2CAN070401

SUBJECT: License Amendment Request
Shutdown Cooling Automatic Closure Interlock Removal
Arkansas Nuclear One, Unit 2
Docket No. 50-368
License No. NPF-6

Analysis of Proposed Technical Specification Change

Proposed Technical Specification Changes (mark-up)

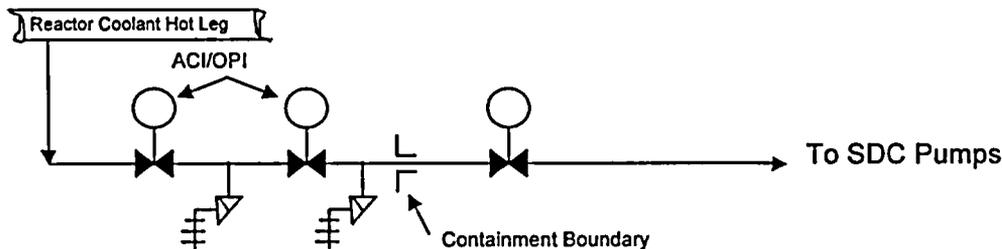
Although the reactor coolant pressure boundary ends at the second isolation valve inside containment, the penetration of the piping through the containment barrier is considered a GDC 55 (Reference 2) penetration based on the 10 CFR 50.2 definition of the reactor coolant pressure boundary (RCPB) (Reference 3). This results in a third in-series motor-operated valve located just outside of containment. The containment isolation valve is normally de-energized and locked closed. The low pressure piping downstream of the second inside isolation valve is protected from overpressure by a relief valve which is an acceptable automatic isolation device in this configuration. System configuration is illustrated simplistically below:
